Rappe Park Oliva Addition; KPB File 2023-114
 McLane Consulting Group
 Triple-Knot Land & Livestock LLC, Oliva
 Location: Park Road
 Nikiski Area / Nikiski APC

ITEM #5 - PRELIMINARY PLAT Rappe Park Oliva Addition

KPB File No.	2023-114
Plat Committee Meeting:	December 11, 2023
Applicant / Owner:	Louis and Stacy Oliva of Nikiski, Alaska
Surveyor:	James Hall / McLane Consulting Inc
General Location:	Park Road and Sara Jane Street, Nikiski, Nikiski APC

STAFF REPORT

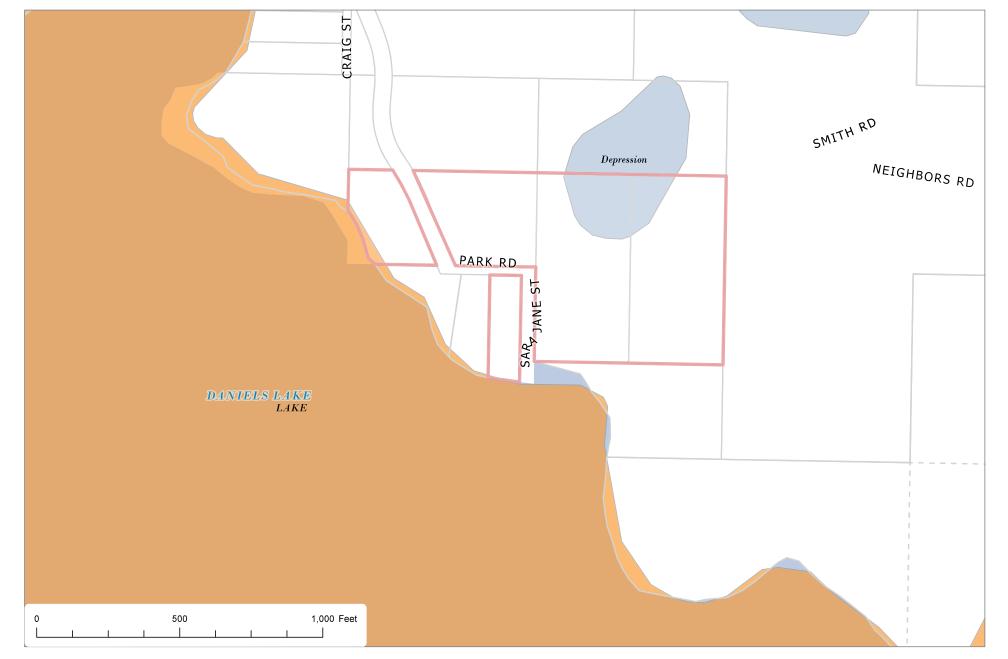
Change the KPB File no to 2023-114

Add to the owners Triple Crown Land & Livestock LLC and address, listed as owners of Lot 1 Rapper Park. Change A. in Stacy A. Oliva to Ann as shown on the KPB Assessing page for ownership.

Add Gov't Lot 37 to the legal description.

Show the patent easements #1234325 in Gov't Lot 19.

Show the patent easement #1233765 in R/W of Sara Jane Street as not being vacated with this plat or vacation process.

Include dimension data of the ASLS of Park Rd along the side of ROW

Reduce the scale for better visibility and add some street names.

Fix the overstrike of Daniels Lake.

Make Kenai Spur Highway closer to the subject plat.

Correct the area of Lot 17-A, includes the dedicated right-of-wat and ASLS areas.

Add a lot on the west side of Park Rd.

Make the lines around dedication solid Add dimensions to the dedications.

Add the area to the east dedication.

Need to add lot on west side of Park Rd.

Areas of grade over 20% need shown

No street names given. Get with KPB Addressing for approved names.

Need bearings and distances on existing Park Rd and new dedications

Add behind the names on the signature lines under the Certificate of Ownership, the lots signing for. Add behind Stacy A. Oliva on the signature line of the Certificate of Ownership 'aka Stacy Ann Oliva' Add the date of December 11, 2023 to the Plat Approval.

Add a Certificate of Acceptance

Show base bearing.
